City of Albuquerque

Interoffice Memorandum

Subject: Review of model for Albuquerque Asphalt's Hot Mix Asphalt plant

Permit # 3291-M2

Figure 4: 24hour PM_{2.5} results including background, but not secondary formation

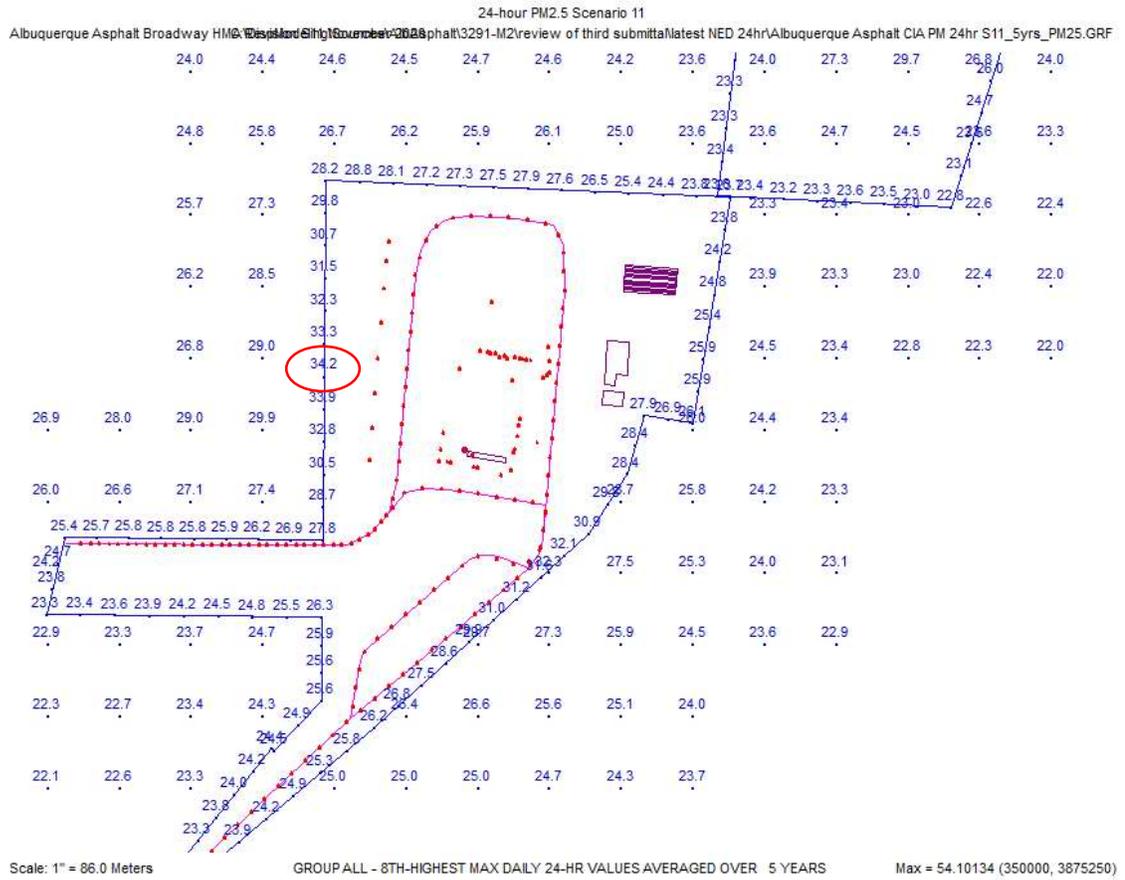
The values circled in Figures 4, 5, and 6 are the modeled impacts plus background values as shown in Table 5. However, each figure shows a higher maximum value in the lower right corner. Those higher maximum values would be violations of the PM NAAQS except that they occurred inside the property of the aggregate plant. The AQP analyzed each of these ostensible violations of the NAAQS. When the impacts of the aggregate plant itself were removed, the seeming violations vanished inside the aggregate plant property.
